Amendment Application for the Proposed Kokerboom 1 Wind Energy Facility in the Northern Cape Province

Draft Amendment Report for Public Comment

DEA Ref:14/12/16/3/3/2/985

Figure 2: Proposed optimised layout for Kokerboom 1 Wind Farm and associated infrastructure superimposed over mapped environmental sensitivities

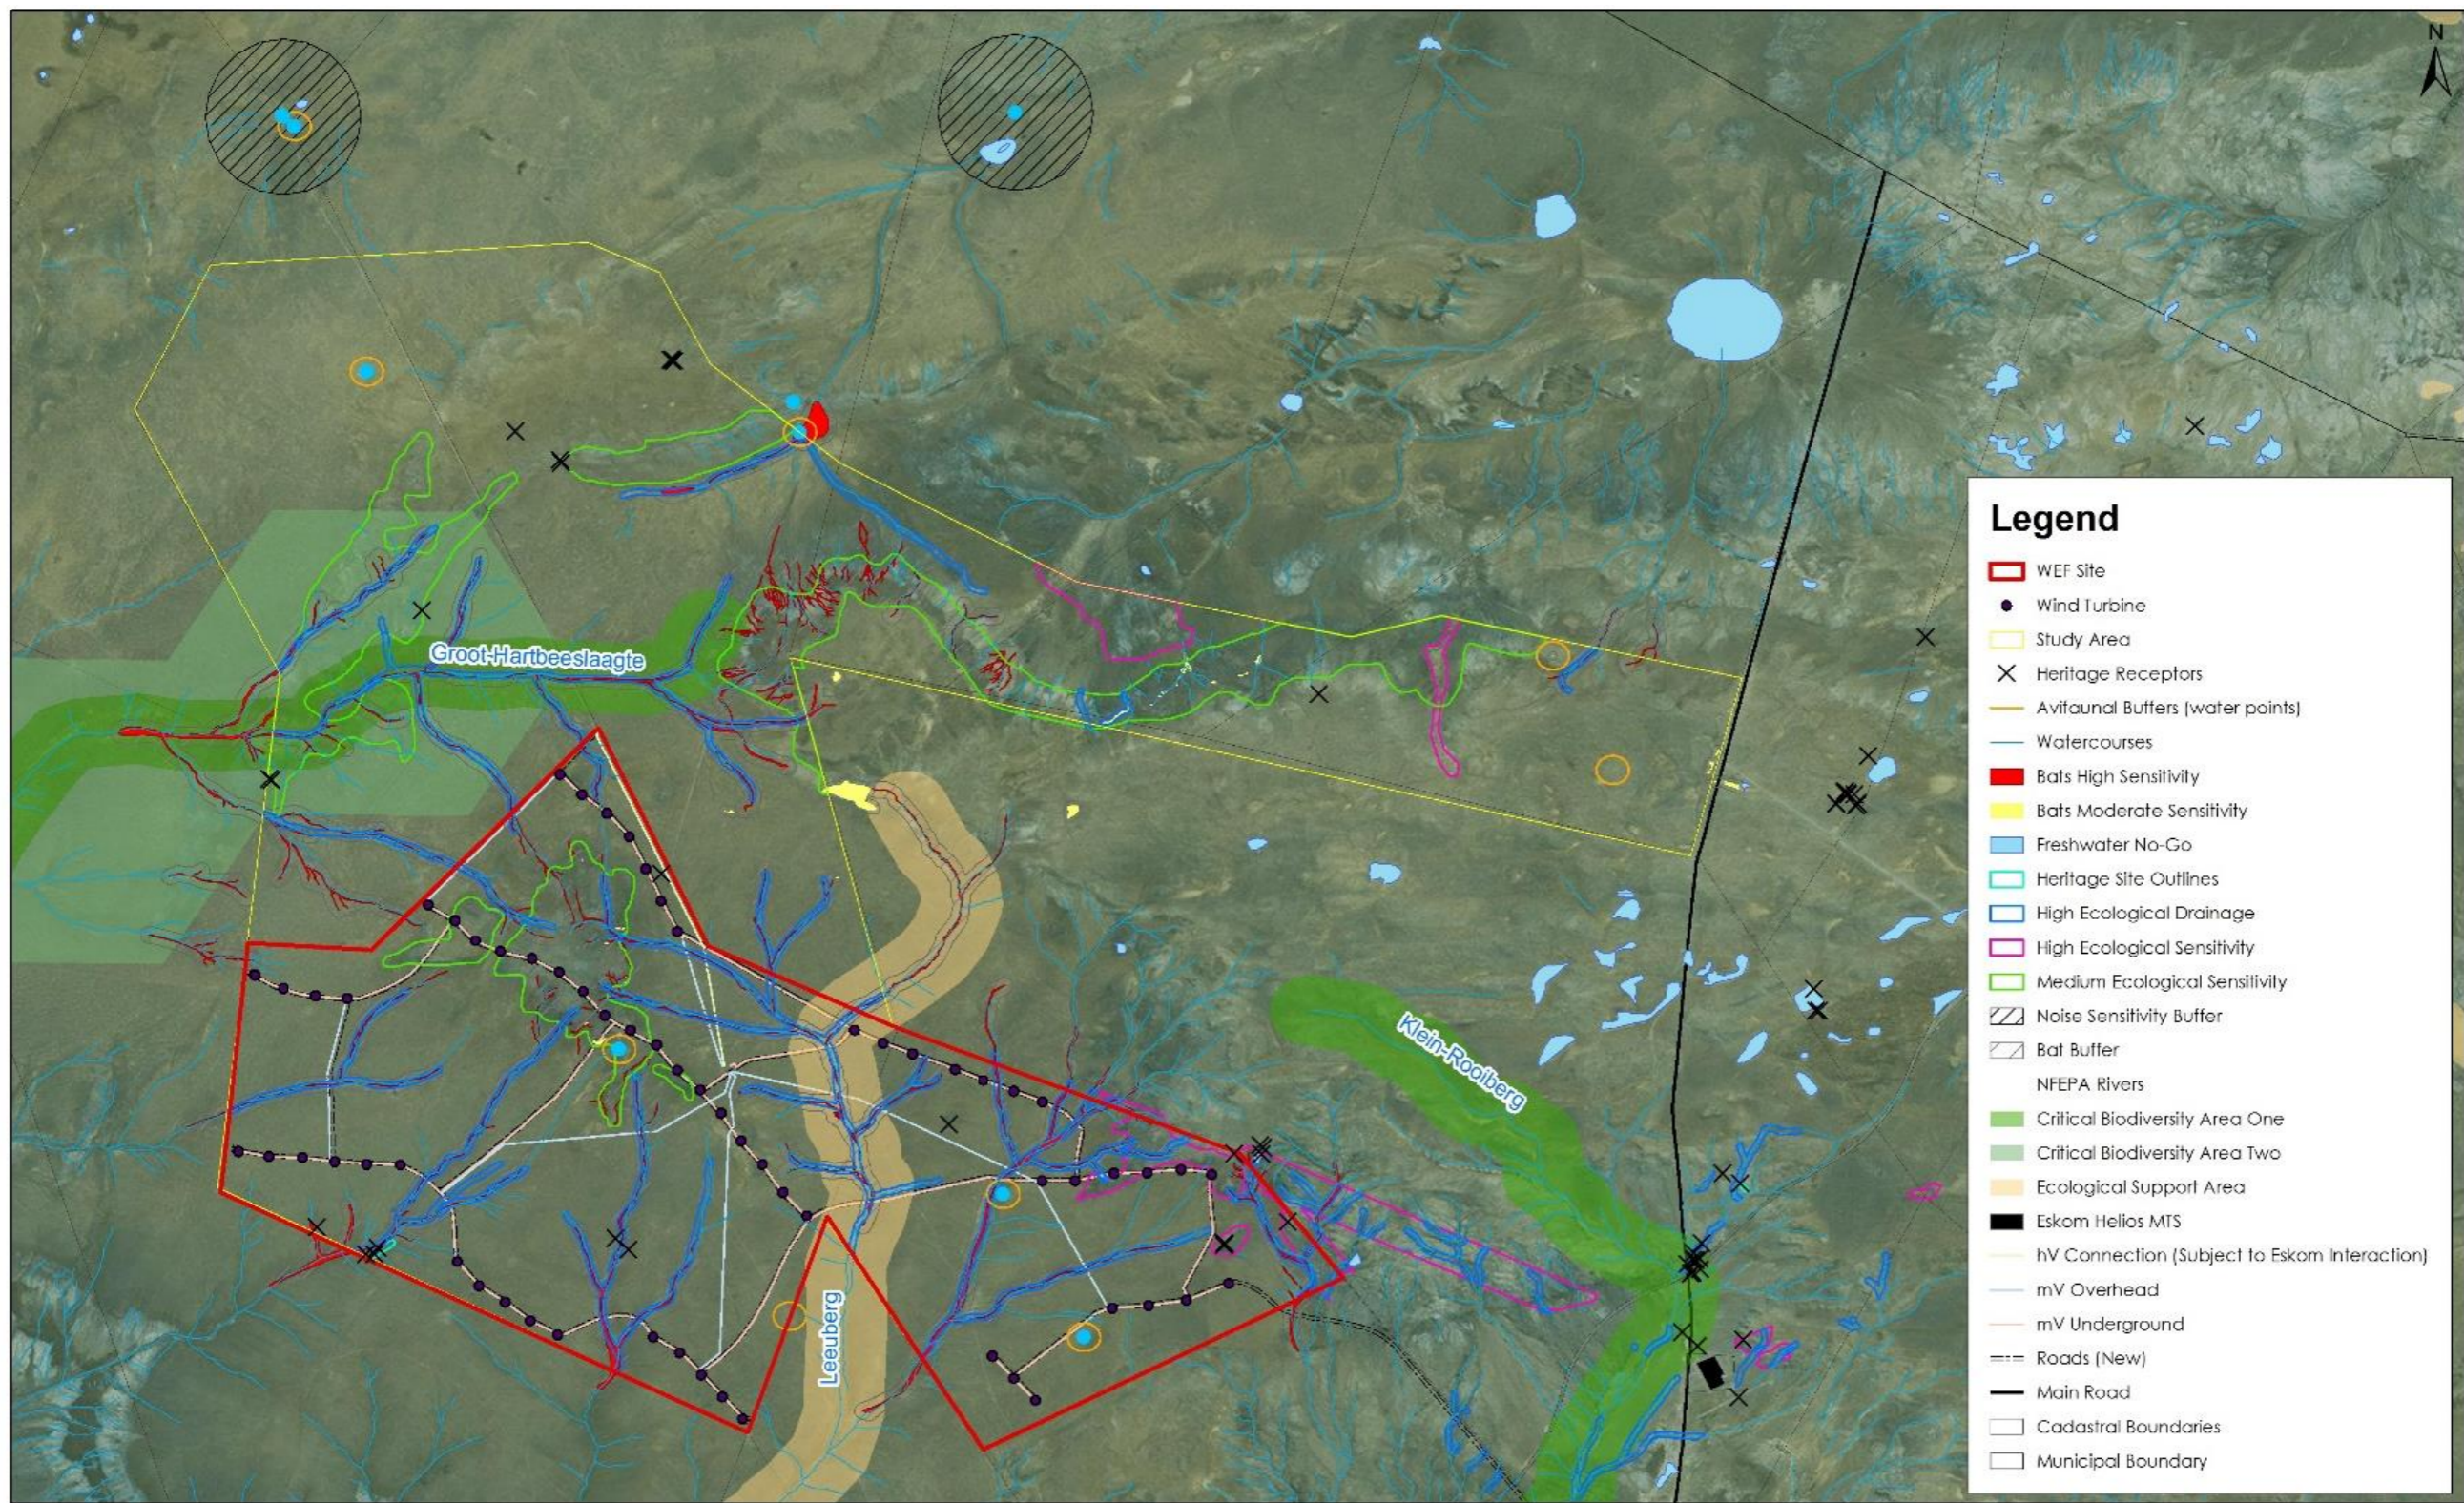
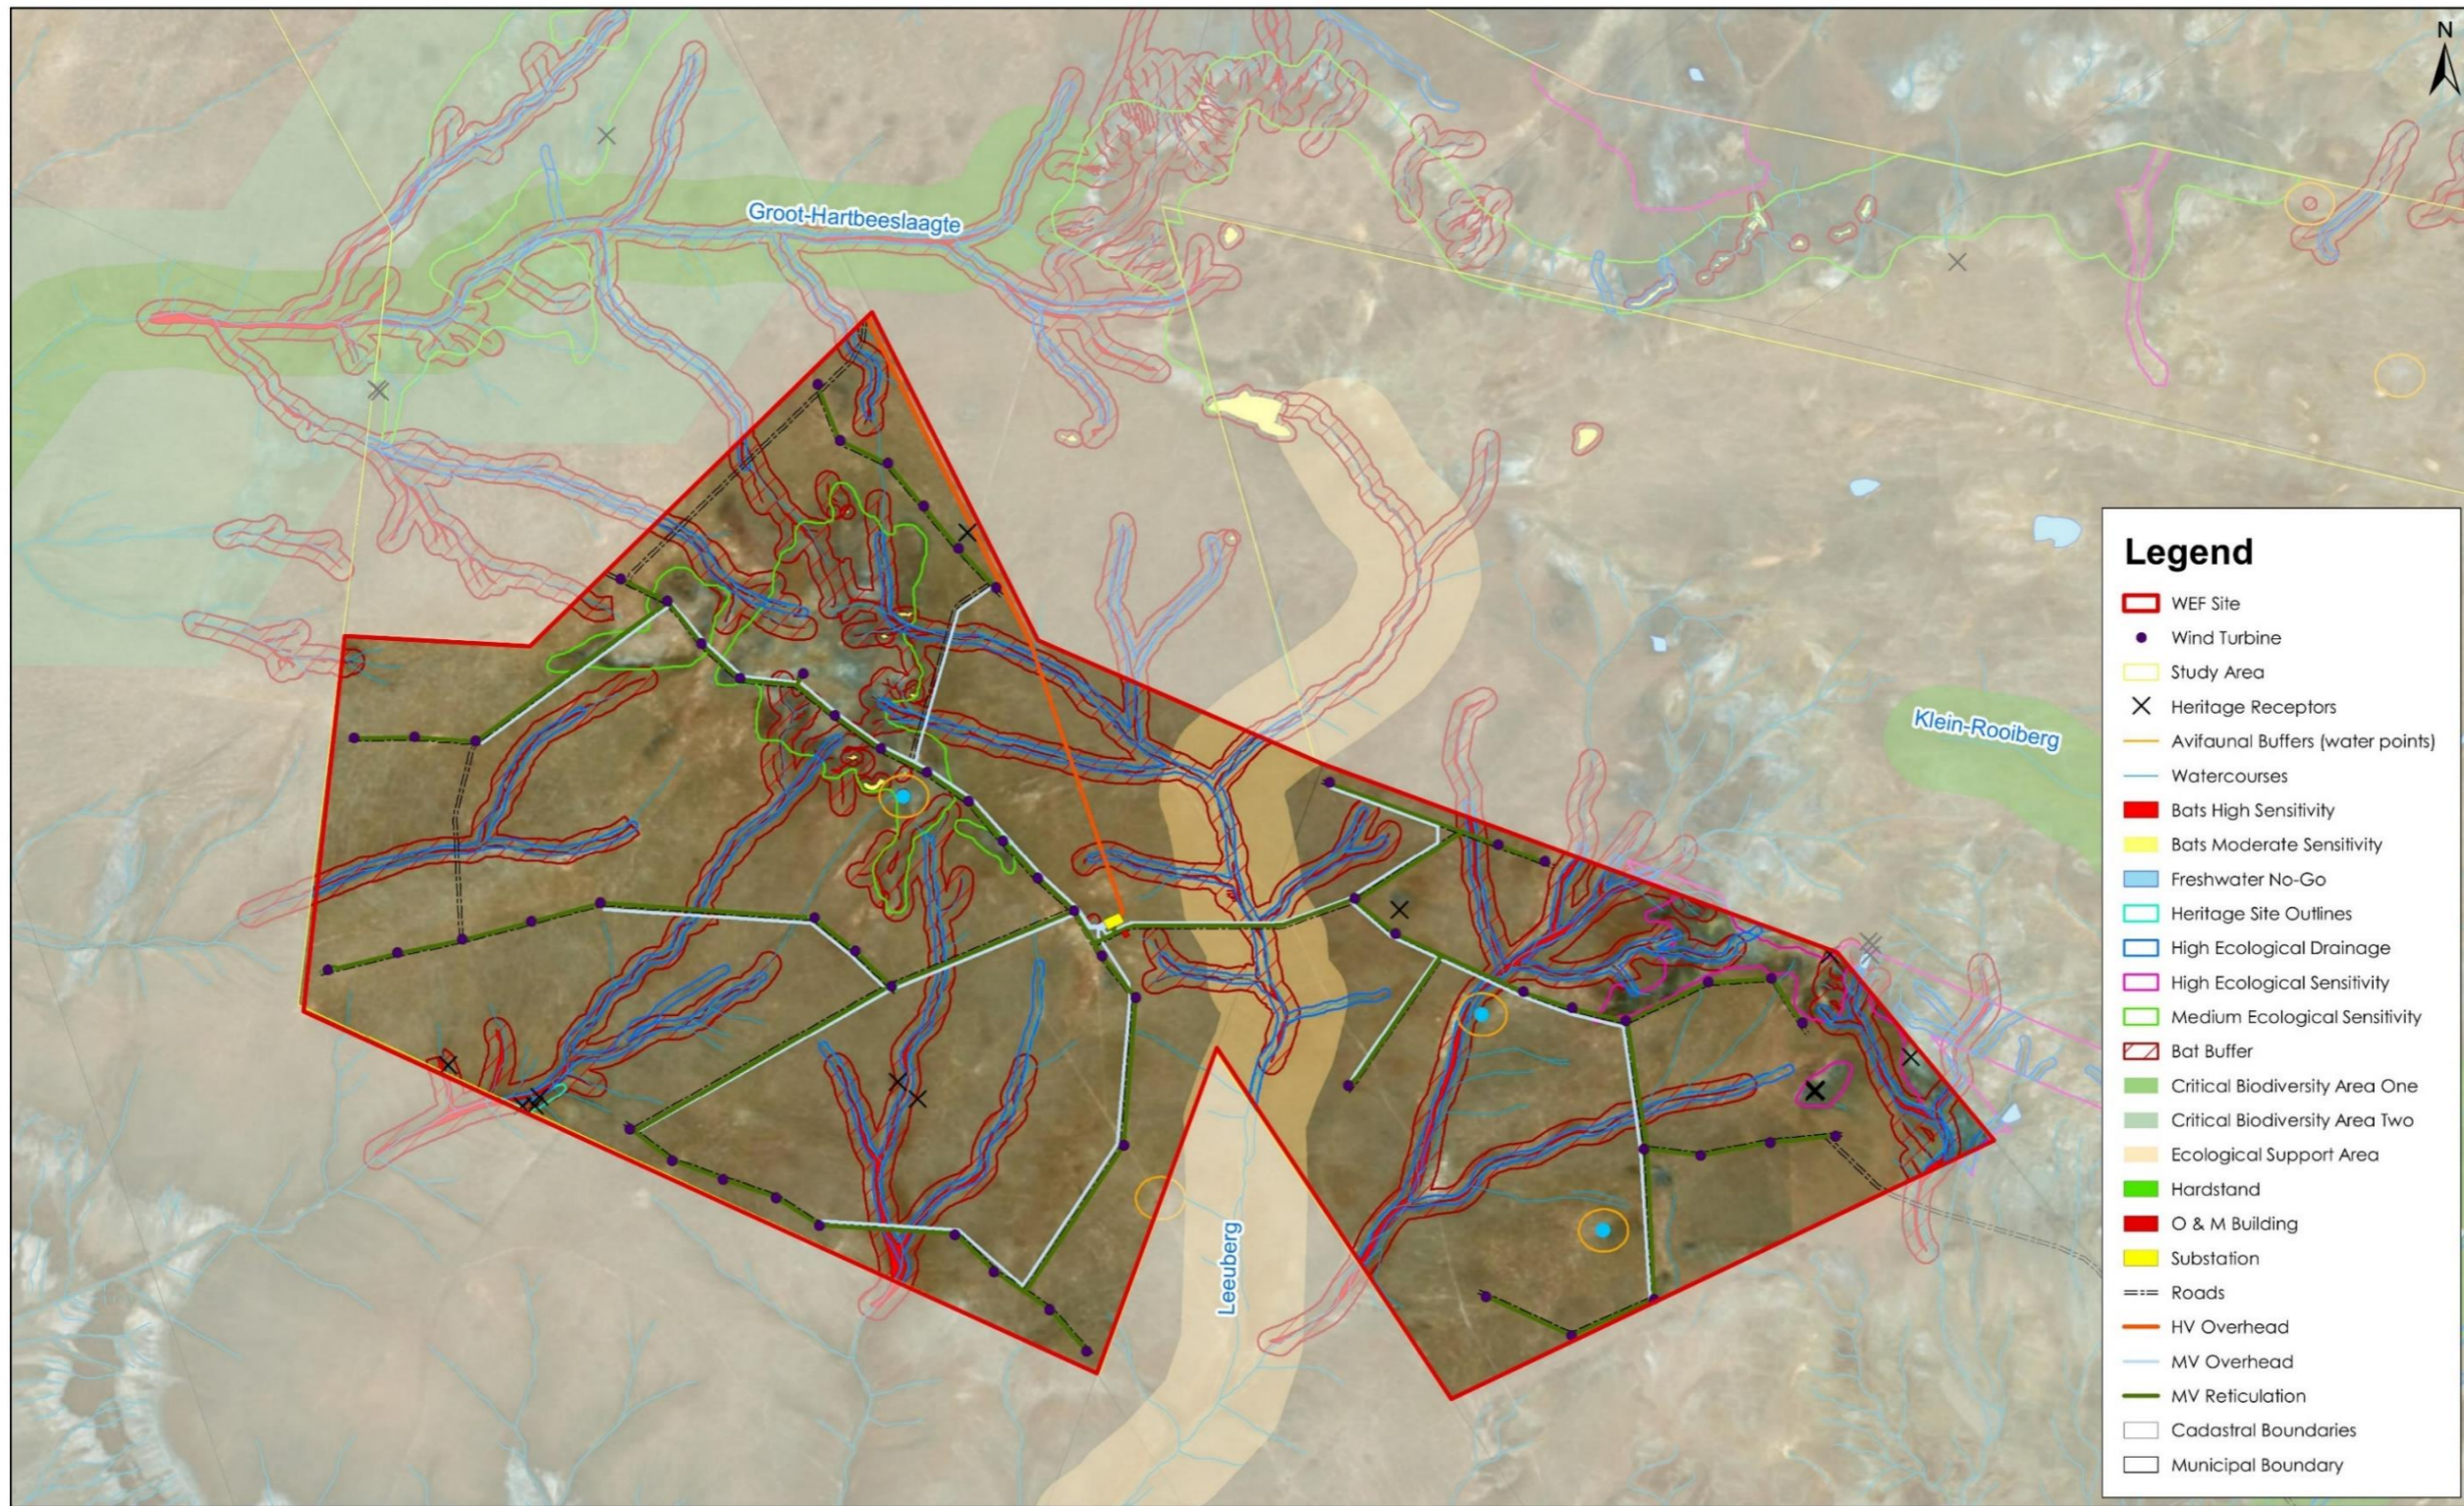
Business Venture Investments No 1788 (Pty) Ltd, is applying for an amendment that would allow for increased hub height, rotor diameter, the power generation capacity of the turbines and larger foundation areas. As a result, the Kokerboom 1 Wind Farm layout would need to be re-designed/ re-optimised in response to the revised turbine specifications, while taking into account environmental sensitivities (Figure 2). Table 3 below provides describes the amendments required to the authorised project specifications and scope.

In order to cater for the larger turbine specifications, it is necessary to revise the site layout plan to provide sufficient spacing between the larger turbines, for safety reasons and to reduce internal wake effects between turbines. The balance-of-plant infrastructure (i.e. internal roads, cables, substation, hard stands etc.) has been revised and optimised in order to cater for the revised turbine positions. The revised turbine locations and associated balance-of-plant infrastructure are all located within the footprint that was previously assessed in the original EIA.

In addition, a length of overhead high voltage (HV) powerline is required to link the wind farm's substation to the Eskom switching station (the latter forms part of a separate EA) in order to export the electricity generated by the wind farm. Due to the costs associated with the HV powerline, the most direct route between the substation and switching station has been proposed, to minimise the length of the powerline. As a result, the proposed overhead HV routing deviates from the internal road network.⁴

⁴ This length of overhead HV powerline was assessed in the original EIA and forms part of the site layout plan that was submitted to DEA with the final EIA Report (Figure 1). However, Condition 58 of the EA stipulates that all cables must follow internal roads. It is now requested that this condition be amended (see Table 4) in order to allow for the overhead HV powerline to deviate from the road network and follow a more direct route to the new onsite substation location as shown in Figure 2.

Component	Authorised	Proposed Amendment
Facility area	<ul style="list-style-type: none"> Proposed project footprint: 6,716ha Temporary construction footprint: approximately 155ha Permanent footprint: approximately 80ha 	<ul style="list-style-type: none"> Proposed project footprint: 6,716ha Temporary construction footprint: approximately 154ha Permanent footprint: approximately 75ha
Site access	The site will be accessed via a proposed new access road on Farm RE/227, which will branch off the Nuwepos Road (preferred alternative).	No amendment required.
Export capacity	Up to 256MW.	No amendment required.
Number of turbines	Up to a maximum of 64.	Up to a maximum of 60 ² .
Turbine generation capacity	Up to 4MW.	Up to 6.5MW.
Hub height from ground level	Up to 150m.	No amendment required.
Rotor diameter	Up to 150m.	Up to 180m.
Blade Tip Height²	Maximum upper tip height: 225m Minimum lower tip height: 40m	Maximum upper tip height: 240m Minimum lower tip height: 40m

Area occupied by substations	Approximately 14,400m ² .	No amendment required.
Location of substation	30°27'36.92"S 19°26'1.58"E	A new location is proposed approximately 850m southeast of the authorised substation location (30°28'6.42"S 19°26'15.88"E).
